M27 Southampton Junction 8  
Highways England  
Stage 2 Road Safety Audit

Document reference: HE551514-SWE-HGN-  
ZZ-RP-ZZ-50001

## Report Title                    Stage 2 Road Safety Audit

**Figure 4.1: Carriageway Text Markings**

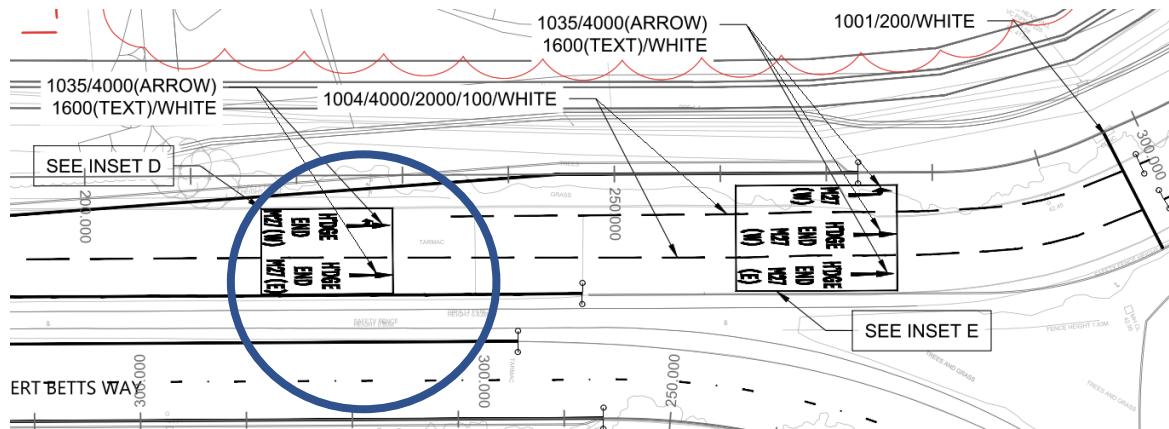
**Summary:** Incorrect lane positioning due to unclear carriageway text and supporting road sign may increase the likelihood of side swipe type crashes.

On the eastbound approach to the M27 junction 8 roundabout on Bert Betts Way, carriageway markings indicate that lane 1 (on the two lane approach) support straight ahead, and left turn movements to Hedge End and the M27, Figure 4.1. As vehicles proceed eastwards towards the proposed traffic signals an additional 3<sup>rd</sup> lane is provided. The direction to Hedge End is marked as lane 2 & lane 3 only. There is a danger that if traffic is queuing back from the traffic signals that the text markings on the carriageway will be covered showing the three lane text markings. Unfamiliar drivers may therefore utilise lane 1 of the three lanes assuming this is the marked direction to Hedge End. As drivers approach closer to the circulatory any drivers positioned in lane 1 for Hedge End noting their incorrect lane selection, may attempt to select lane 2 therefore increasing the potential for side swipe type crashes.

It is recommended that a dedicated lane advance direction sign is included on the Bert Betts Way approach to the junction 8 roundabout circulatory to supplement the carriageway markings and to provide greater clarity of lane selection for route destination. Note Traffic Signs Sheet 2 of 5 drawing ref: HE551514-SWE-HSN-ZZ-DR-CH-50002 indicates sign ES2-08 on the eastbound approach to the traffic signals. This sign is not shown on the sign schedule, but it is assumed this sign is the map type sign showing the roundabout ahead with route directions (see Figure 4.2), and therefore does not fully aid drivers with lane selection.

For additional clarity, the removal of the road markings proposed in INSET D above, and replacement with an additional set of the proposed markings shown in INSET E may aid route finding. A similar approach on the westbound approach to Windhovor roundabout may also be adopted.

**Figure 4.3: Roundabout circulatory markings at Junction 8 M27**

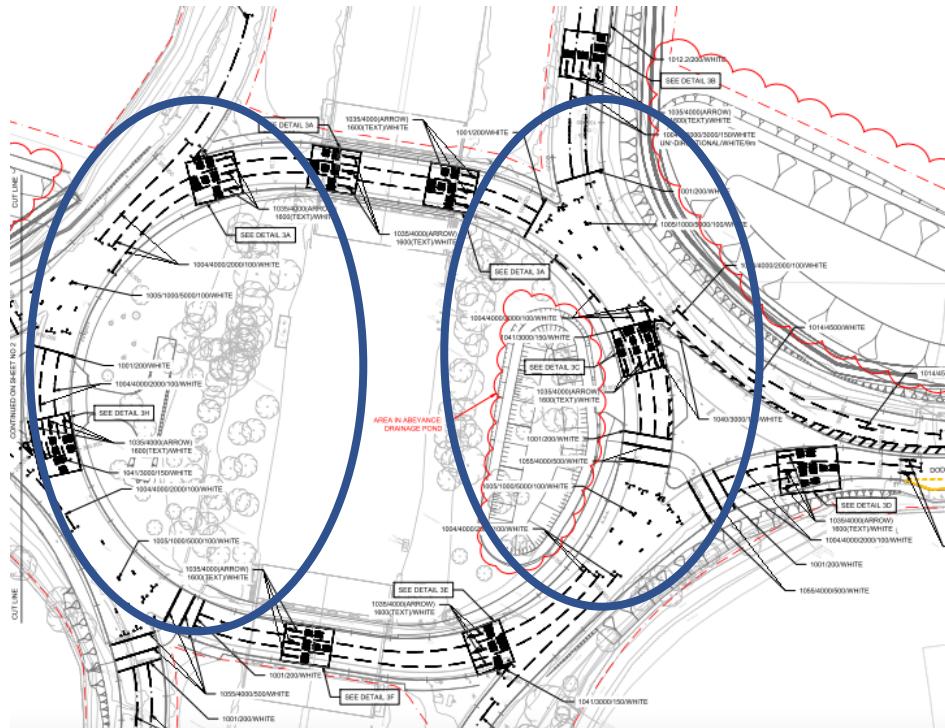
**Summary:** Unclear carriageway markings may lead to increased likelihood of side swipe type crashes.

The M27 Junction 8 roundabout circulatory proposes to utilise 1005 road markings to help guide road users to the appropriate lane and onward destination. Due to the variable number of entry and exit lanes from the roundabout arms compared to the number of circulatory lanes, there is a danger that the proposed road markings may not offer sufficient guidance to road users to enable them to naturally enter their desired receiving lane. This may result in driver hesitation and lead to an increased likelihood of side swipe type crashes.

It is recommended that full/improved spiral road markings are introduced on the roundabout circulatory and entering and receiving lanes to provide clear guidance to road users.

**Figure 4:4 Road markings proposed on Windhov roundabout**

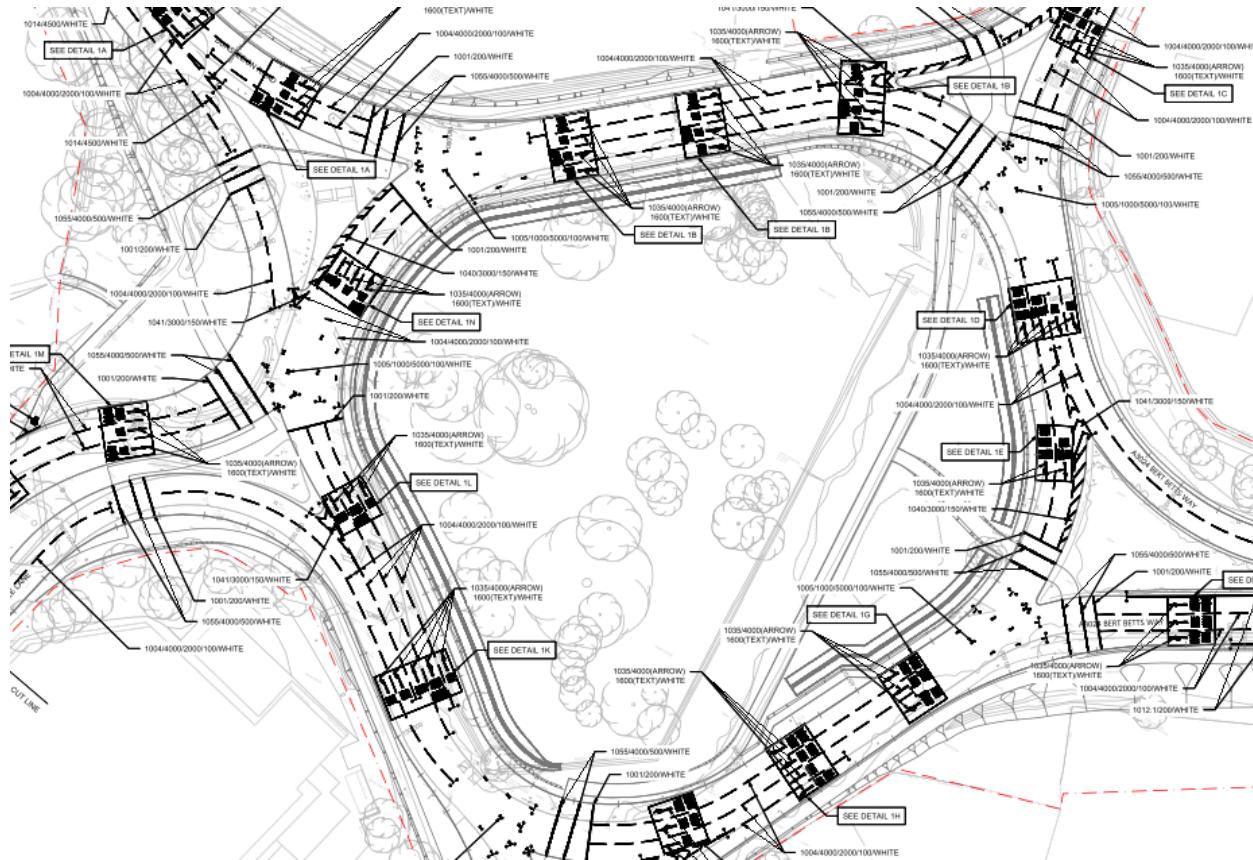
**Summary:** Unclear carriageway markings may lead to increased likelihood of side swipe type crashes.

Windover roundabout includes 5 arms (Figure 4.4). Each arm includes between 1 and 3 carriageway lanes in each direction to reflect traffic flow requirements. The roundabout circulatory also includes a variable lane balance to reflect the entry and exit traffic flows for each arm. Windhover roundabout therefore has a changing lane balance throughout the circulatory between 2 and 5 lanes. This changing lane balance, particularly for unfamiliar drivers, may result in difficulties in way-finding. This is most likely to pronounced when attempting to negotiate the area past the signal stop line on the roundabout circulatory where proposed guidance markings for circulating and turning vehicles provide limited information for road users. The absence of clear and concise information to drivers in terms of lane selection may result in driver hesitancy and potentially an increased likelihood of side swipe type crashes.

It is recommended that full / improved spiral road markings are introduced throughout the roundabout to aid way-finding.

**Figure 4:5 Road marking showing the division of north and southbound movements.**

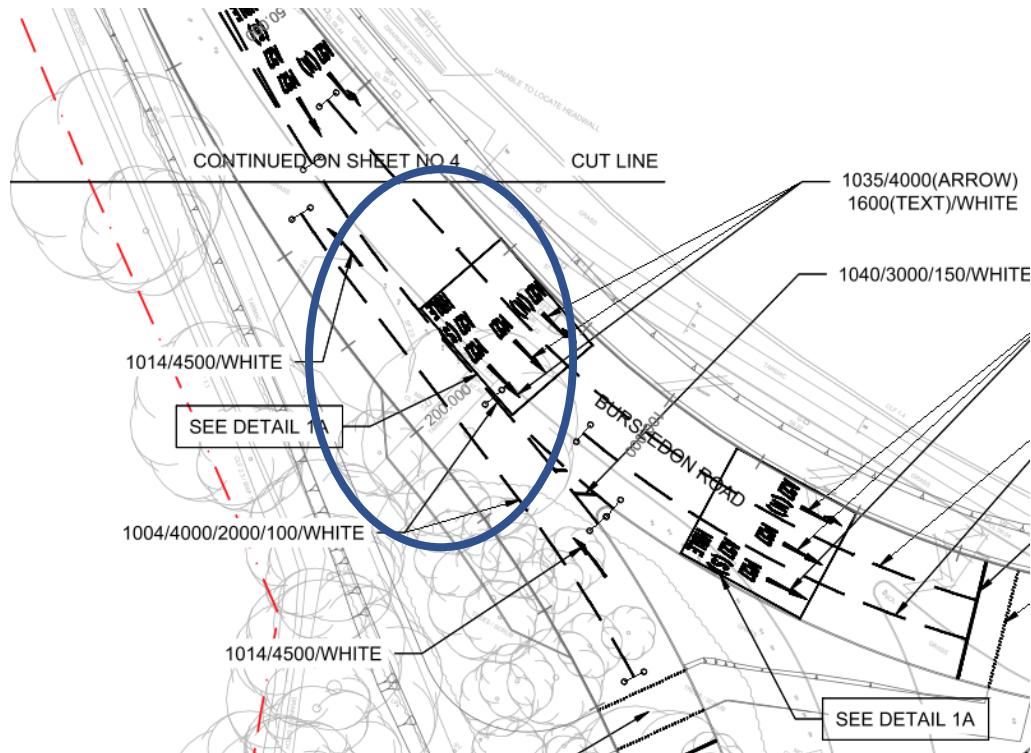
**Summary:** Two northbound and three southbound lanes are divided by a centre line road marking only at a location where lane re-positioning may take place therefore potentially resulting in an increased likelihood of head-on type crashes.

Bursledon Road entry and exit to Windhovre roundabout includes two northbound and three southbound lanes as shown in Figure 4.5. North of the splitter island there is a limited length of hatched road marking and then a central line road marking separating north and southbound traffic movements. As northbound vehicles are attempting to merge into the left side lane at this location, and southbound vehicles are also repositioning themselves to select the appropriate lane there is an increased likelihood that north and

southbound vehicles may overrun the centre line at this location therefore potentially resulting in an increased likelihood of head-on type crashes.

It is recommended that the central hatching is extended from the splitter island to provide additional separation between north and southbound carriageways.

**Figure 4:6 Hatched area of carriageway on the approach to Providence Hill**

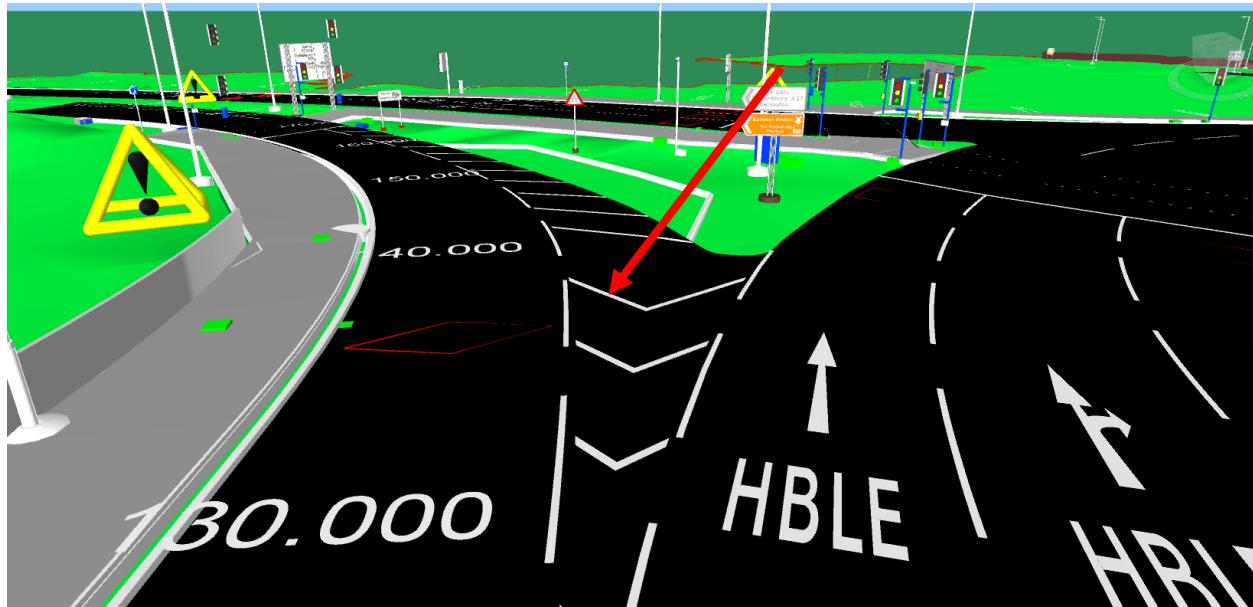
**Summary:** Excessive hatched area of carriageway may be utilised by both crossing vulnerable road users and vehicles entering Providence Hill therefore introducing a potential conflict area and collision involving vulnerable road users.

Southbound entry into Providence Hill from Windhover roundabout includes one lane entry. On the offside of the entry lane there is an extended length of hatched road markings as identified with the red arrow in Figure 4.6 below. The hatching extends either side of the proposed signalised Toucan crossing.

The presence of the proposed hatching raises a number of road safety concerns. Firstly, the hatching will introduce an excessive amount of 'dead' carriageway space that in the absence of vehicle runover is likely to collect debris and rubbish that may create a hazard for any vehicle that enters the hatched area, due to reduced skid resistance. Secondly, users of the Toucan crossing may feel confident waiting in the carriageway in the area shielded by the hatching. This may potentially expose users of the Toucan of an increased risk of vehicle strikes and injury if approaching vehicles overrun or utilise the hatched area.

It is recommended that the hatched area is reduced and replaced with an extension to the physical island, (whilst retaining sufficient space to enable the passing of any broken down vehicle at this location). This will provide a shorter crossing distance for vulnerable road users, remove the lack of clarity of the use of the road space, and reduce the necessity for highway sweeping.

**Figure 4.7: Lane guidance signs on Providence Hill/Windhover Circulatory**

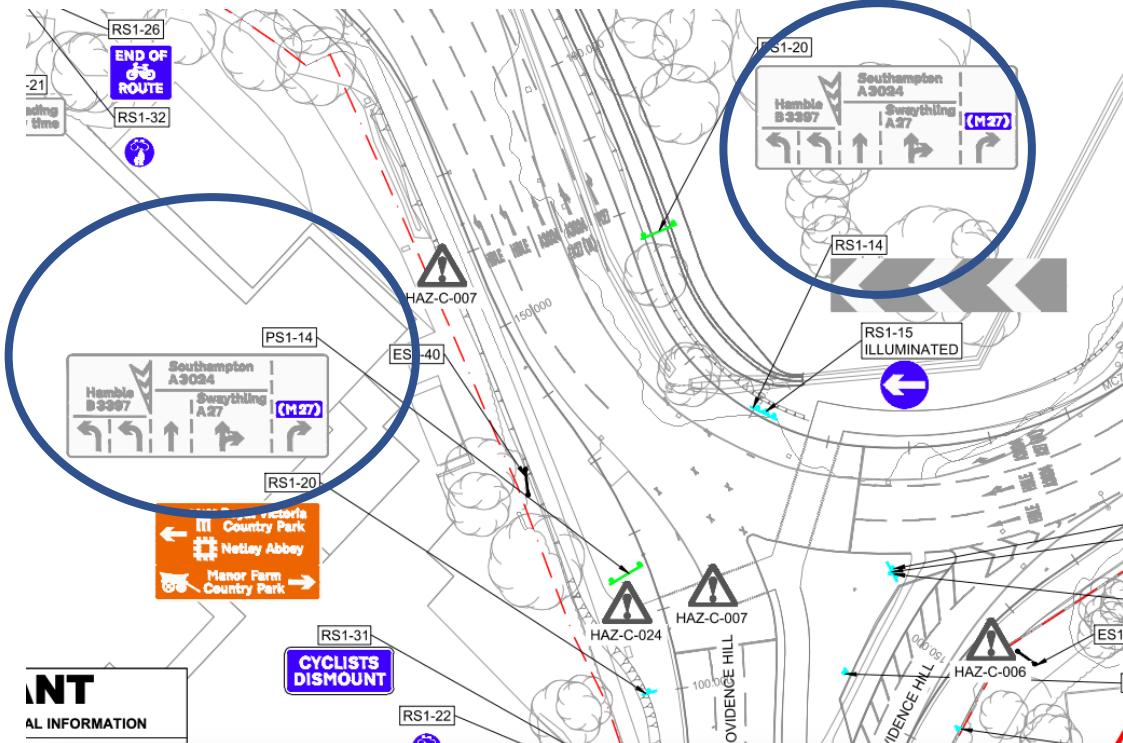
**Summary:** Position of lane destination signs may not provide clear guidance to road users.

On the Windhover roundabout circulatory between the arms serving Providence Hill and Hamble Lane five circulating lanes are proposed. To provide guidance to road users text is provided on the carriageway to show lane destination. The text markings are supported by sign reference PS1-20 which is proposed to be located on the offside of the carriageway and shown in Figure 4.7. Due to the proposed location on the

right side of the carriageway where 5 lanes are present there is a concern that vehicles circulating on the left side of the roundabout may fail to see the directional sign, particularly if a high sided vehicle is masking the sign. Unfamiliar drivers may therefore be unclear of the appropriate lane to select for their onward route leading to possible hesitancy and side swipe crashes from late lane changes.

It is recommended that sign reference PS1-14, which provides lane guidance information, is relocated forward of its current position in a north-westerly direction so it is placed alongside the roundabout circulatory where it may be visible to northbound traffic from Providence Hill as well as circulatory traffic.

**Figure 4.8: Lane guidance sign proposed position provides limited forward visibility**

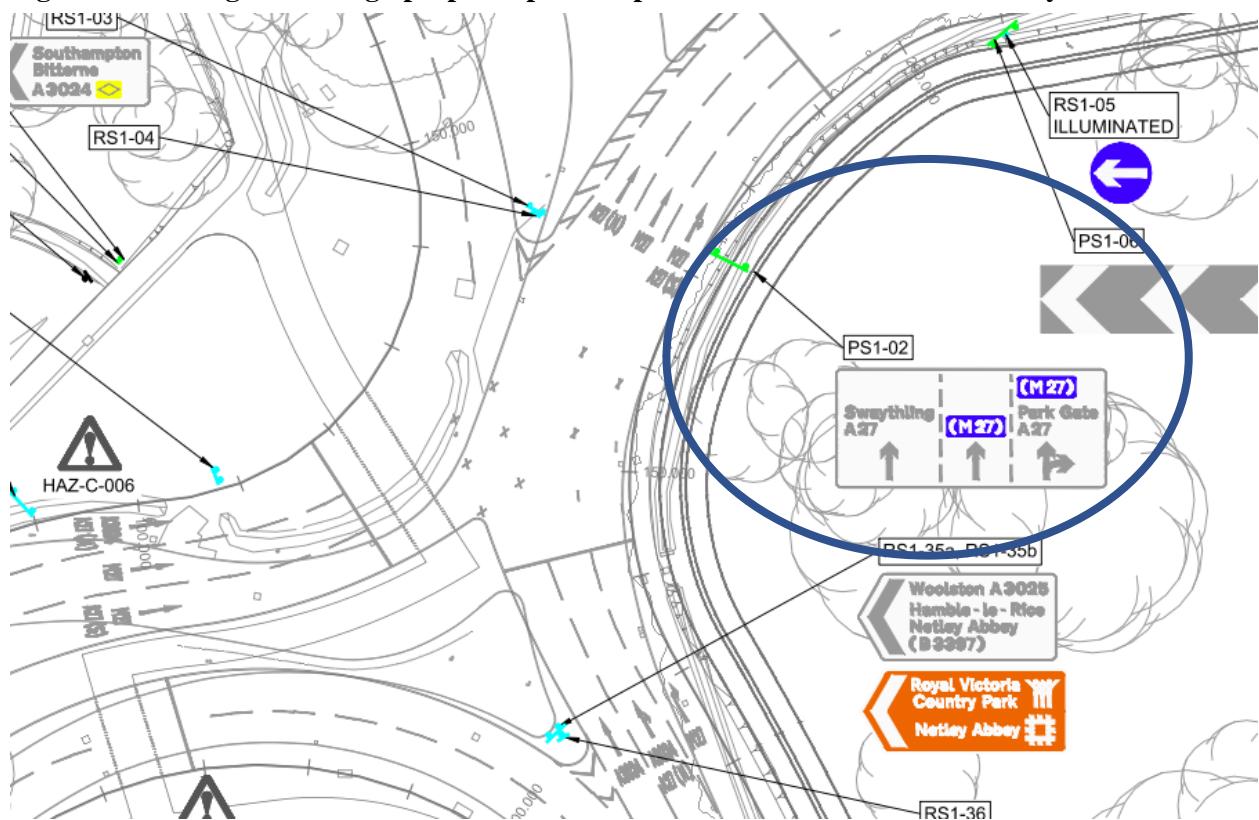
Road sign PS1-02 as shown in Figure 4.8 provides lane destination information for road users on Windhover roundabout and is located on the northern side of the roundabout between Hamble Lane and Bursledon Road arms. The proposed position of the sign provides limited visibility to circulating vehicles

on the roundabout until the sign position is reached due to approach radius on the circulatory. Similarly, for vehicles travelling east on Hamble Road towards Windhoover roundabout, the proposed position of sign reference PS1-02 also appears to provide limited advance guidance to road users until the roundabout circulatory is entered. Poor way-finding information may result in driver hesitancy and late, last minute lane changes.

It is further noted that at this location, and throughout the circulatory, the vertical road sign provides place name directional finding, i.e A27 Swaythling & A27 Park Gate. In contrast, the carriageway markings indicate A27 (N) and A27 (S). This reflects existing provision, but may not fully inform unfamiliar drivers, adding to potential hesitancy in drivers and subsequent increased likelihood of conflicts.

It is recommended that signage is positioned so that it provides clear advance information to road users. The application of an addition N (north) and S (south) symbol on vertical signage may also aid route finding.

In addition, the application of full spiral road markings as raised in PROBLEM 4.2.3 above, will provide further clarity on lane selection, thereby reducing the likelihood of possible late lane change movements and potential resultant side swipe type crashes.

**Figure 4.9: Circulatory carriageway markings**

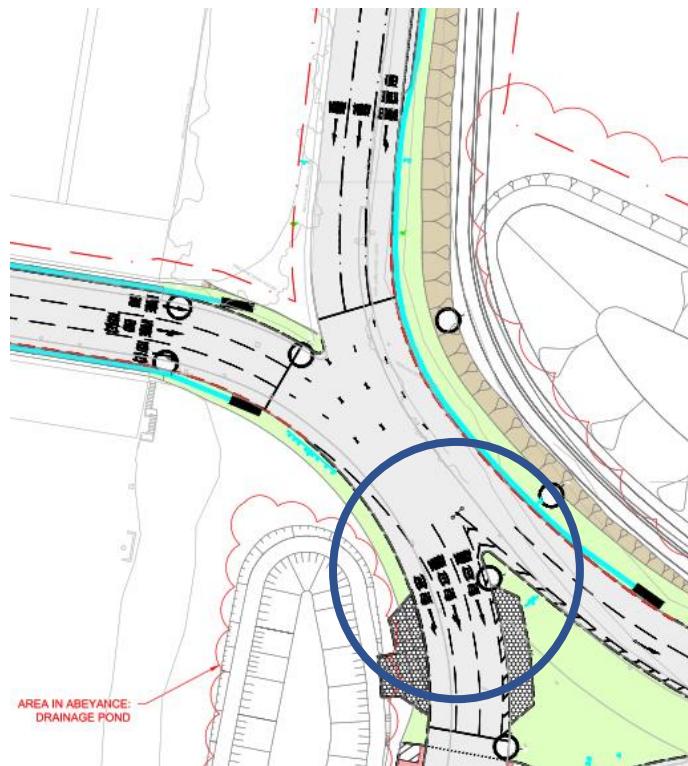
**Summary:** Confusing lane allocation markings may lead to lane change side swipe type collisions.

On the southbound circulatory carriageway the lane allocation markings appear to show both M27 (E) and A3204 traffic using lanes 1 and 2 of the circulatory carriageway. It is acknowledged that these traffic streams are separated within the signal phasing / staging however, in peak traffic periods excessive queuing may mean that these traffic streams are mixed and this may lead to A3204 traffic in lane 1 crossing M27 (E) traffic in lane 2 at the gyratory exit. This may lead to side swipe type collisions.

It is recommended that the circulatory traffic lane allocations are amended to remove the potential conflict. It would appear that the 3<sup>rd</sup> lane allocation for M27 (W) appears to be unnecessary and could be replaced with A3204, which would mean that lane 1 of the circulatory could be marked for M27 (E) only; this would require minor amendments to spiral markings.

**Figure 4.10: Gap between sections of VRS**

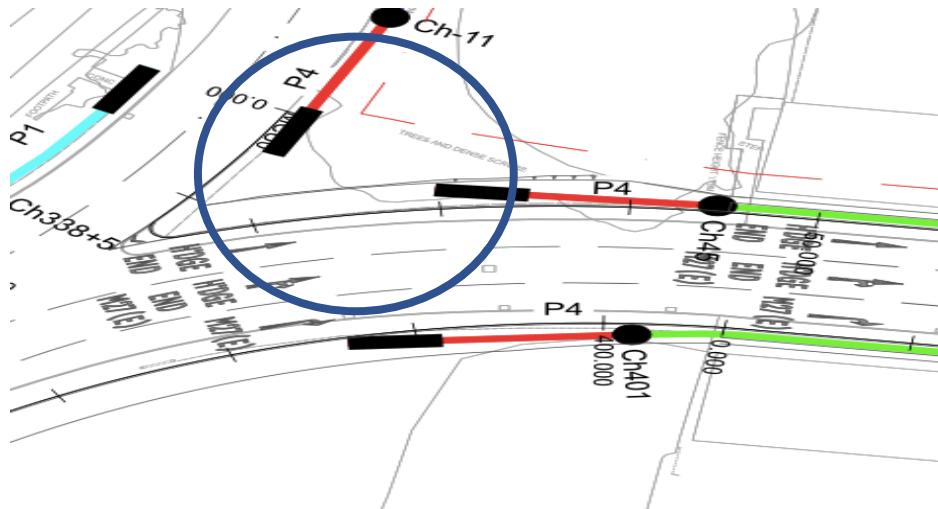
**Summary:** Proposed sections of VRS do not appear to fully protect roadside hazards therefore presenting a hazard to an errant vehicle

Proposed VRS detail on the entry slip to the M27 westbound at the junction 8 roundabout indicates two sections of VRS, one section running alongside the offside of the westbound entry slip, and a further section of VRS continuing on the outside of the junction 8 circulatory as shown in the sign drawing and 3D model screenshot images in Figures 4.10 & 4.11.

The proposed arrangement for VRS provides a gap between the two sections of VRS which an errant vehicle may enter. The road safety concern is exacerbated as the current situation appears to show that two existing directional signs and a motorway dot matrix sign is provided at this location and will appear to be unprotected by the new arrangement. Note: the sign drawing indicates sign reference ES3-07 only at this location, and this sign is not listed in the provided schedule, so sign information and post detail is not known.

It is recommended that roadside furniture is adequately protected by VRS, alternatively passively safe posts are introduced.

**Figure 4.13: Highlighted section where VRS is removed on the M27 J8 circulatory.**

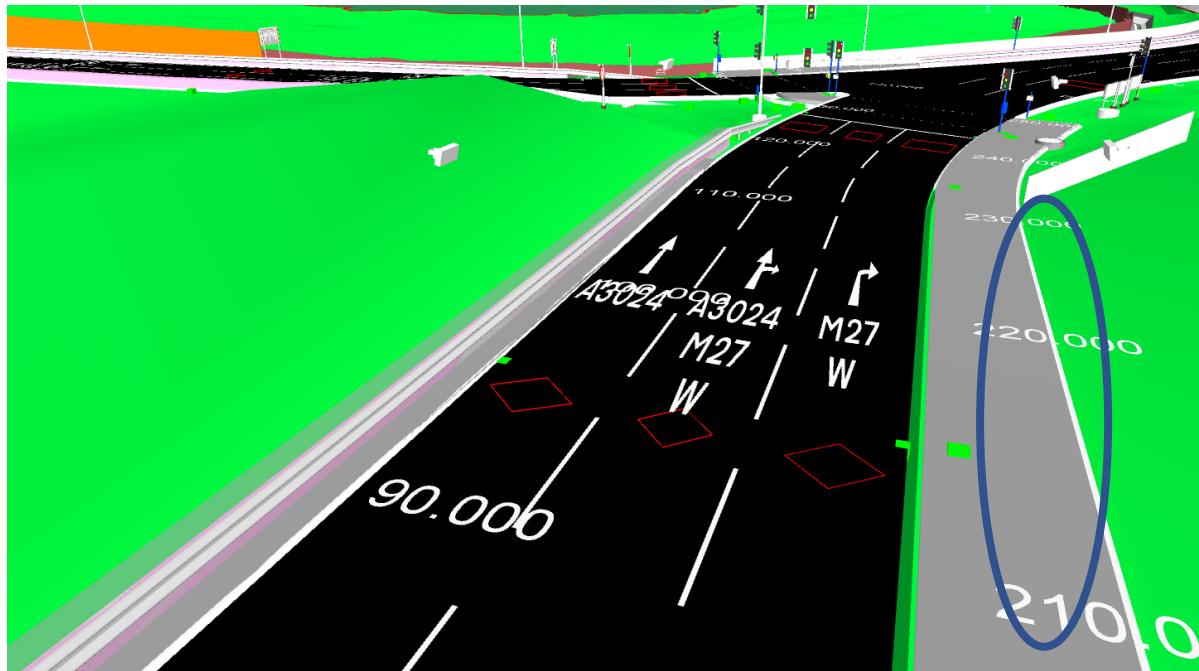
**Summary:** Removal of VRS on the roundabout circulatory increases the risk of strikes to vulnerable road users and the bridge piers.

On the southern side of the roundabout circulatory of the M27 junction 8 roundabout, the existing vehicle restraint system is being removed from the inner side of the circulatory area, as highlighted in Figure 4.13. The existing restraint system currently offers protection to the bridge piers which support the M27 over the roundabout. The restraint system proposed to be removed from this location will be replaced with a High Containment Safety Kerb which is designed to allow the introduction of a shared cycle/pedestrian route. There is a concern that an errant vehicle at this location which strikes the High Containment Safety Kerb (which is proposed to replace the VRS at this location) may be launched and this in turn may result in the vehicle striking a pedestrian/cyclist utilising the shared route, or/and a direct strike on the bridge piers which may result in potential bridge collapse.

It is recommended that a vehicle restraint system is retained at this location to support the bridge piers.
